ADDENDUM

Client: Quincy Public School District #172 Project Name: Health Life Safety Work: Gym Floor Replacement At Quincy Junior High Project Number: 5775 Addendum Number: 01 Issued: 03-05-2019

MODEL 6401 SECOND STORY FLOOR SLEEVE ADAPTER

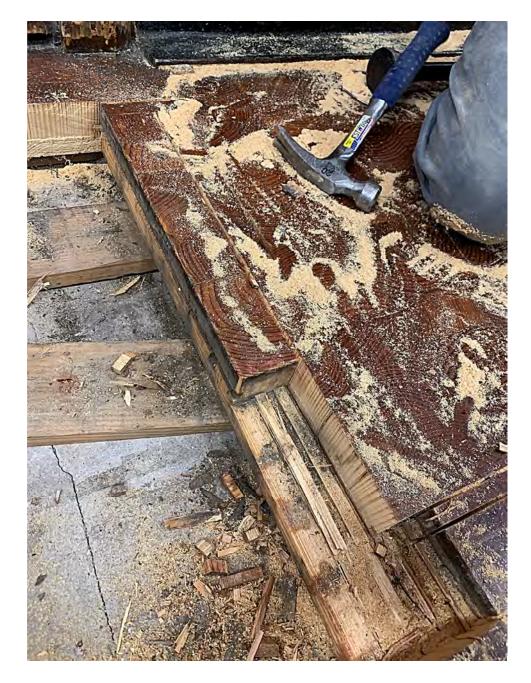
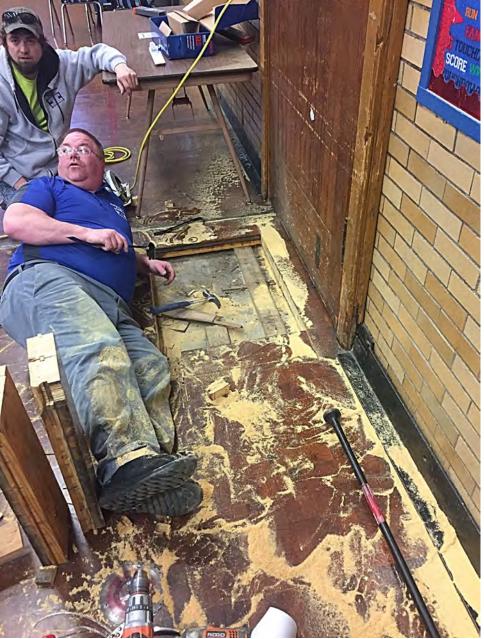
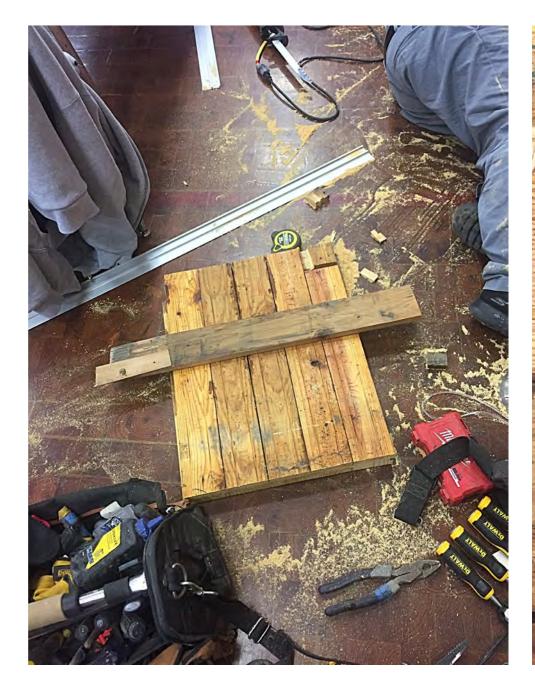
A1.0	Modify	Keyed Note 13 was modified to include the 1x trim board that needs to be anchored to the masonry before the vented base attachment.
A1.0	Modify	Keyed Note 14 was modified to describe the removal of the existing net pole sleeves and installation requirements for the new PSS 6401 pole sleeves. There are (6) pole sleeves total.

Second story floor sleeve adapter is constructed with 6-5/8" O.D. x .156 wall tubing and steel channels. Unit bolts to the underside of the concrete. With adapter in place, floor sleeves may be installed normally.

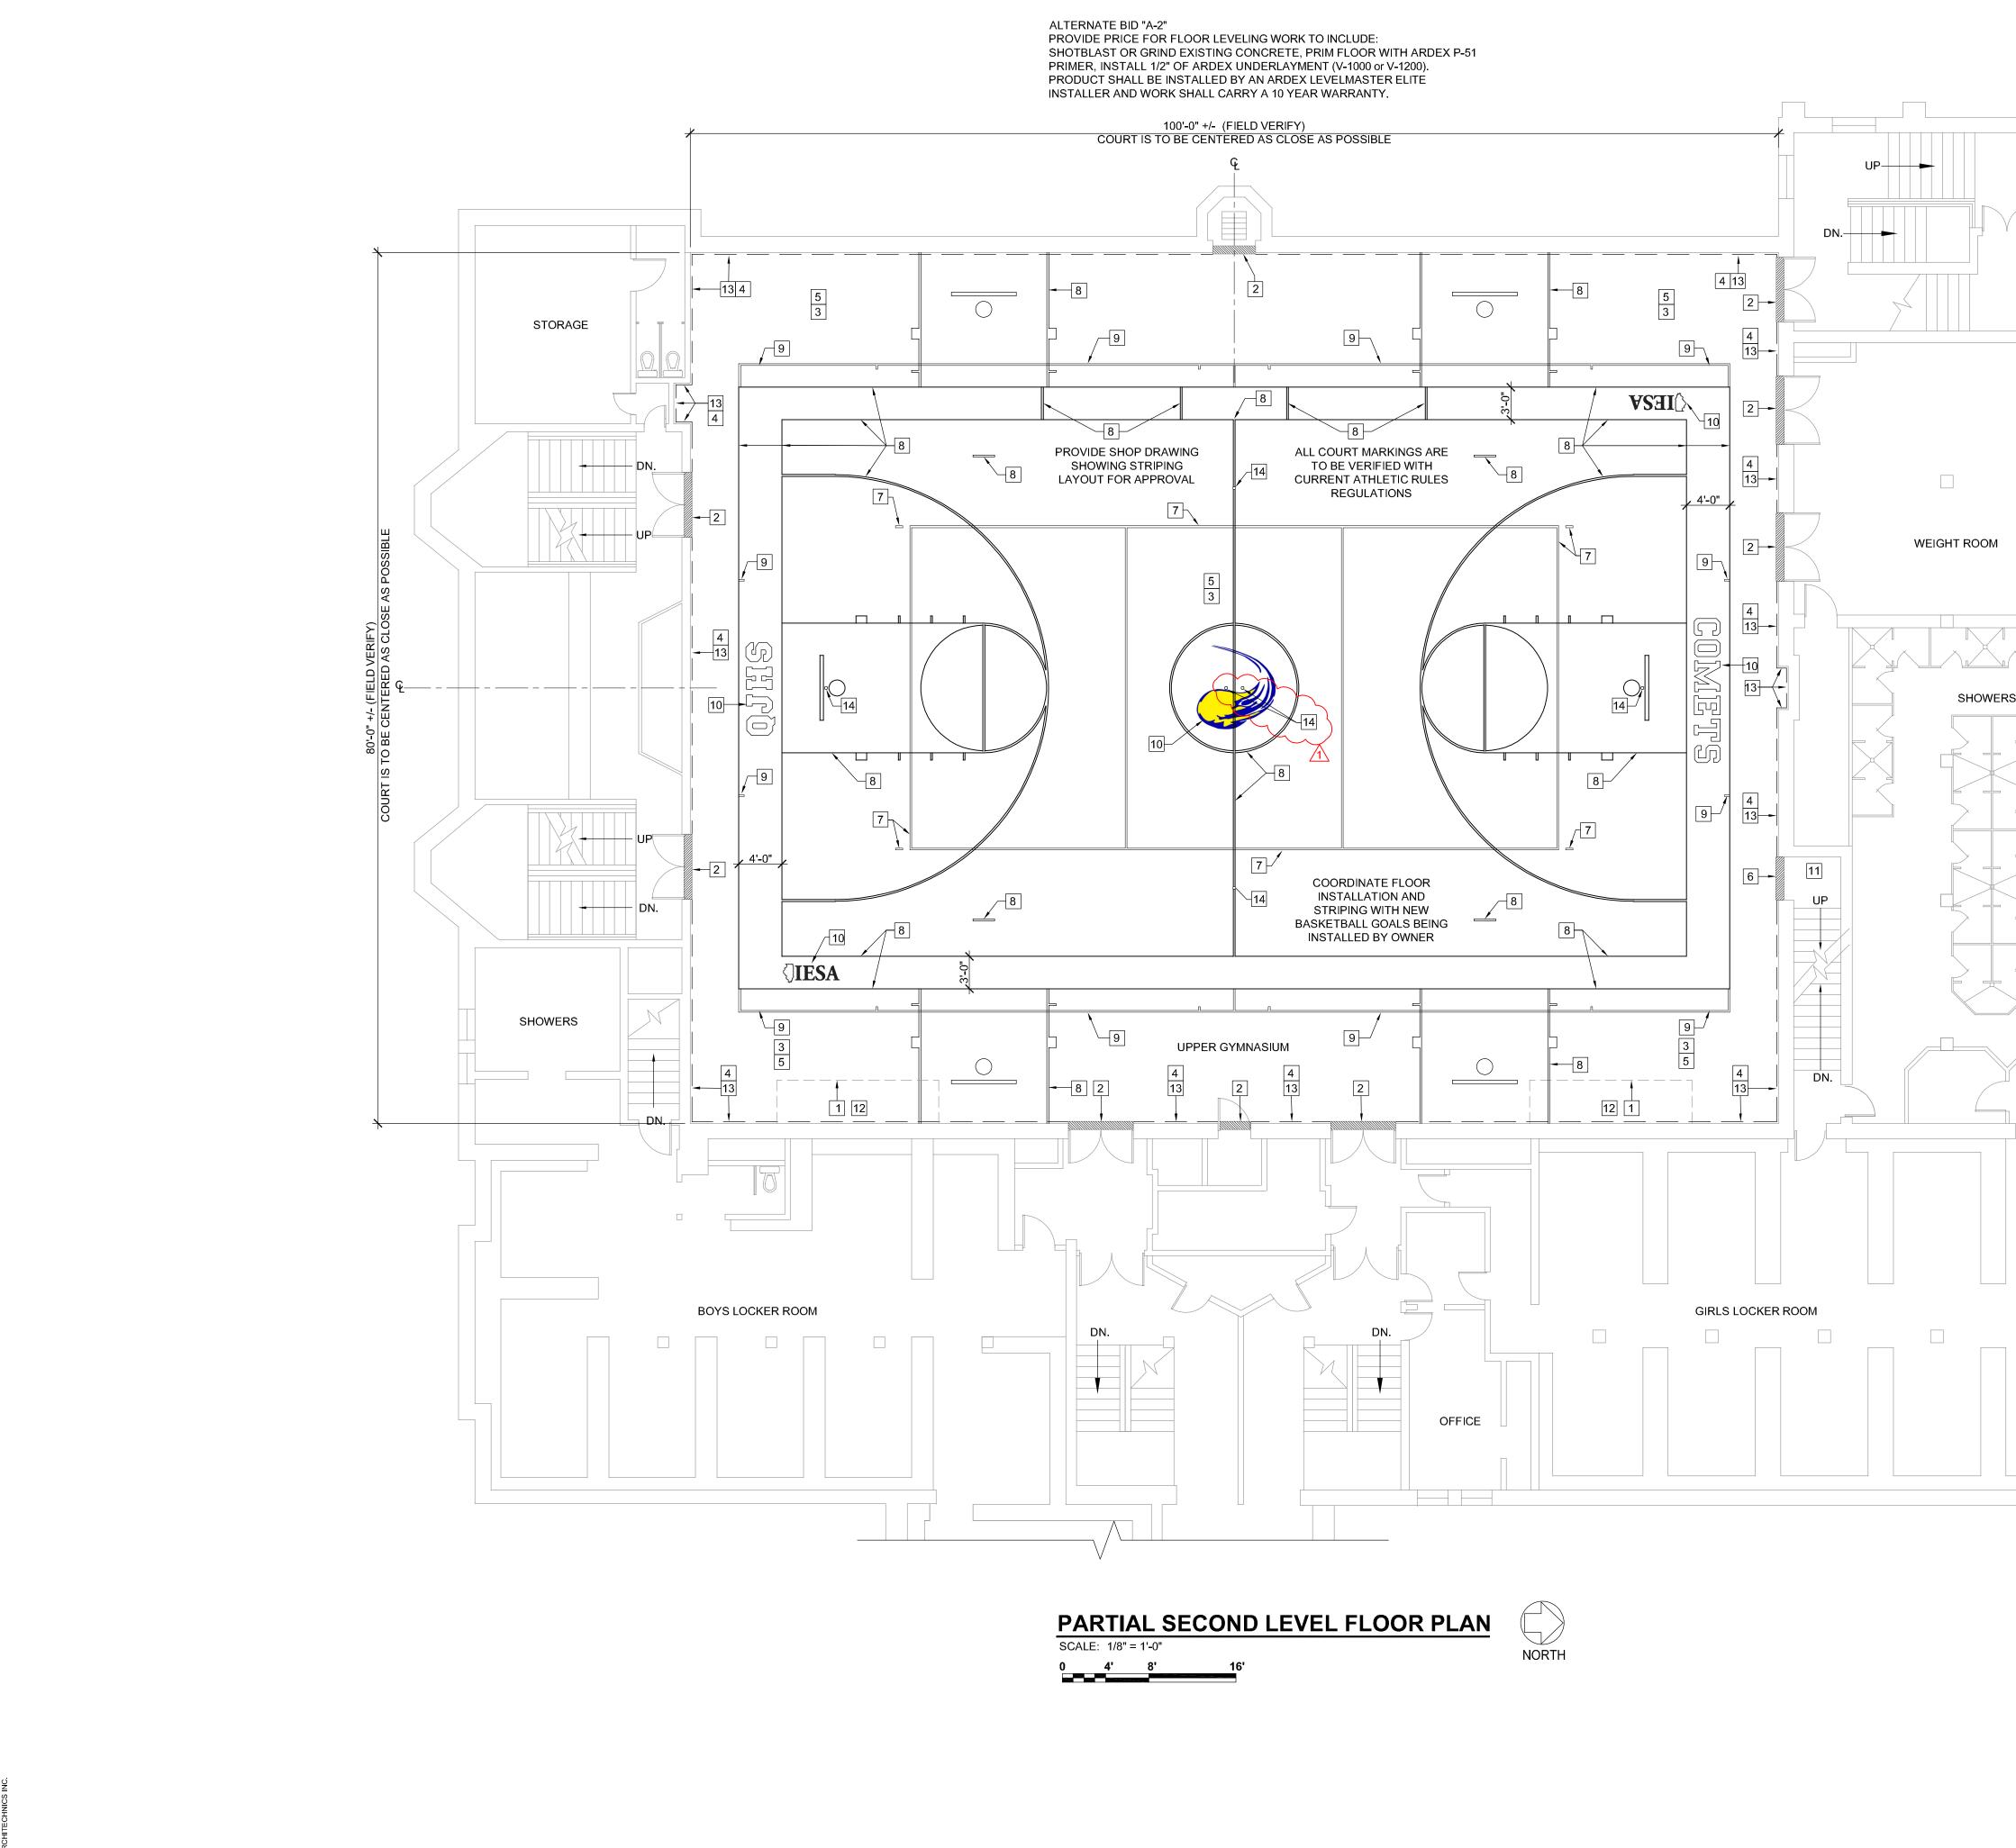
ITEM	DESCRIPTION	NOTES				
See attached pictures of section of floor removed to verify existing floor construction.						
SUBSTITUTIONS (ACCEPTED)						
Sheet A1.0	Add	Robbins Bio-Cushion Classic Flooring System				
SPECIFICATIONS:						
Bid Proposal 00 4200	Modify	See revised bid form attached adding Base Bid "B" Wood Athletic Flooring System and Alternate Bid "B-1" – Floor Leveling -All drawings, requirements, etc apply to this Base Bid "B" -Base Bid "B" - Wood Athletic Flooring System shall be Bio-Cushion Classic system by Robbins with continuous pad. -Base Bid "B" contingency allowance shall be \$20,000.00				
DRAWINGS:						
A1.0	Clarify	New floor striping shall include ~3' solid band around basketball court.				
A1.0	Clarify	Contractor shall coordinate any floor leveling as required and new wood athletic floor system thickness shall be adjusted as required to maintain ADA accessibility with minimum 1/2" elevation difference to existing adjacent floor finish elevations and new 8" threshold.

- 9 NEW SIDE VOLLEYBALL AND BADMINTON COURT MARKINGS, COORDINATE FINAL LOCATION AND COLORS WITH OWNER
- 10 NEW LOGO AND SIGNAGE. COORDINATE FINAL DESIGN AND COLOR WITH OWNER.
- 11 CONCRETE FLOOR AT THE BASE OF STAIRS TO REMAIN.
- 12 UNDER BASE BID "A-1" INSTALL NEW WOOD FLOOR VENTILATION SYSTEM SUPPLIED BY FLOORING MANUFACTURER COMPLETE WITH CONTROL PANEL AND HUMIDITY SENSOR. OWNER WILL PROVIDE POWER TO CONTROL PANEL.
- 13 NEW VENT COVE BASE BY TARKETT. 1x PAINT GRADE TRIM SHALL BE INSTALLED BEFORE NEW VENT BASE IS SECURED. THIS 1X BASE IS TO BE TALL ENOUGH TO HIDE THE TOP LINE OF THE EXISTING BASE. PAINT BLACK. VERIFY AT PROJECT SITE. SEE SPEC 09 6466

14REMOVE (6) EXISTING NET POLE SLEEVES. PATCH AND REPAIR FLOOR AS REQUIRED. PROVIDE (6) NEW NET POLE SLEEVES. ENSURE THAT HOLE PROVIDED IS COMPATIBLE WITH EXISTING EQUIPMENT. VERIFY WITH OWNER. BEFORE STARTING INSTALLATION OF NEW WOOD FLOORING SYSTEM CONTRACTOR SHALL COORDINATE AND VERIFY THE LOCATION OF THE NEW PSS 6401 OR EQUAL(VERIFY COMPATIBILITY WITH EXISTING VOLLEYBALL POLES) VOLLEYBALL SLEEVES TO LOCATIONS THAT WILL ALLOW FOR CENTERING OF THE COURT AS CLOSE AS POSSIBLE TO THE CENTER OF THE GYM. CONTRACTOR SHALL REMOVE EXISTING CEILING BELOW TO ACCESS UNDERSIDE OF SLAB AND LOCATE SLEEVES CLEAR OF STRUCTURAL GIRDERS AND CONCRETE TRUSSES. PATCH AND PAINT AREAS AFFECTED AS PART OF THIS WORK.
